**Linden Hills Small Area Plan:
Addressing requests and conditions from the December 2nd Planning
Commission meeting**

December 5, 2013
Prepared by CPED
Staff: Brian Schaffer

Figure 1. Images from page 47 of Linden Hills Small Area Plan

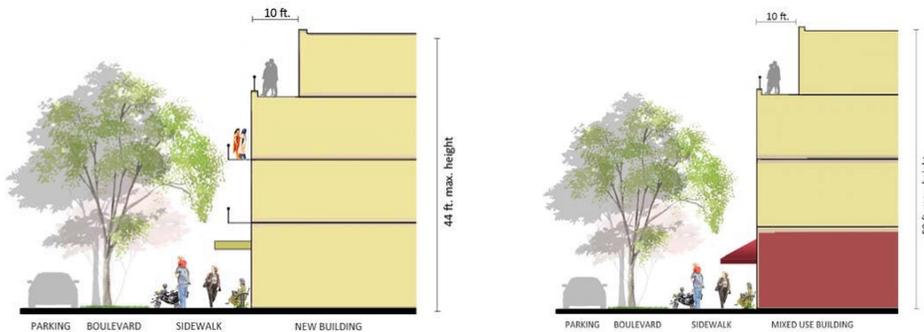
Modified the Specific Implementation Recommendations (from page 46 of the plan) to replace the term “modules” with “massing” and provide more descriptive information followed by ranges of length versus a specific length.

Modify the explanatory language (from page 48 of the plan) to replace the term “modules” with the term “massing”

- Developments should be divided into separate buildings or individual buildings should be articulated through their massing to reflect the architectural context of the neighborhood.

- Within the 43rd & Upton and 44th & Beard Neighborhood Commercial Nodes building massing should be articulated to reflect (1) the commercial character and (2) the fine grained architectural massing of the existing collection of buildings and range between approximately 40 and 60 feet in length along the street.

- Within the 44th & France Neighborhood Commercial Node building massing should be articulated should be articulated to reflect a traditional urban form and range between approximately 60 and 80 feet in length along the street.

- Along the France Avenue and 44th Street Community Corridors, multifamily building massing should be articulated into to reflect (1) the residential character and (2) the fine grained architectural massing of the existing collection of buildings and range between approximately 40 and 60 feet in length along the street.

- The massing of a building should be defined by articulation that has a depth of at least 3 to 4 feet.

Building length and articulation is the other key component of character that this plan focuses on. The plan recognizes that building length and building height together significantly contribute to the character of the existing development patterns for in Linden Hills. Breaking up larger buildings into more authentic **massing** that reflect the existing development patterns is paramount to context sensitive infill development. It is recognized that due to development constraints new developments cannot always be broken up into separate buildings. In contemporary designs, building articulation to break up a building’s massing is common place. However, this articulation is often made through shallow changes in the plane of the building wall and through material changes that rarely result in the building reading as separate buildings that relate to the surrounding context and as a result does not meet the intent of the guidance in this plan. To ensure that the context sensitive building design desired in Linden Hills the delineation of the building **massing** must be clearly defined through significant building wall articulation.

Figure 2 Graphic from Uptown Small Area Plan regarding building height

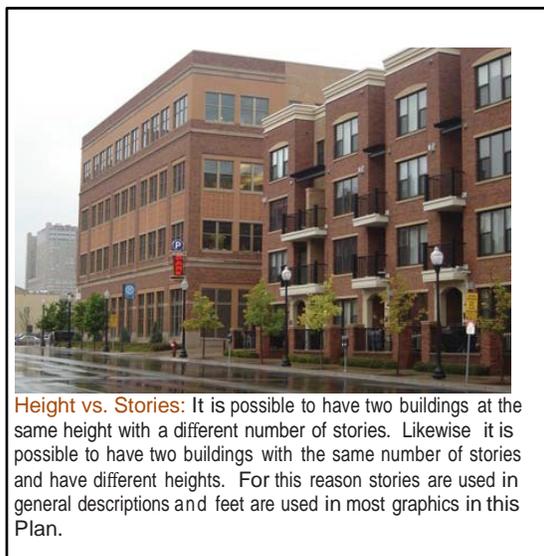
Southwest Sector Plans			
Lyn-Lake Small Area Plan	Lowry Hill East, Whittier, C.A.R.A.G., Lyndale	2009	No, discusses height in stories and corresponding feet
South Lyndale Corridor Plan	Kenny, Lynnhurst, Tangletown, Windom	2006	No, just states stories
Uptown Small Area Plan	East Calhoun (ECCO), C.A.R.A.G., Lowry Hill East and East Isles	2008	List height in feet purposefully over stories, but foot recommendations equate to Zoning Code Definitions of stories. Use 35 feet equates to 2.5 stories. Demonstrates 4 and 5 stories are possible within 56 feet. See pages 74 and 78.
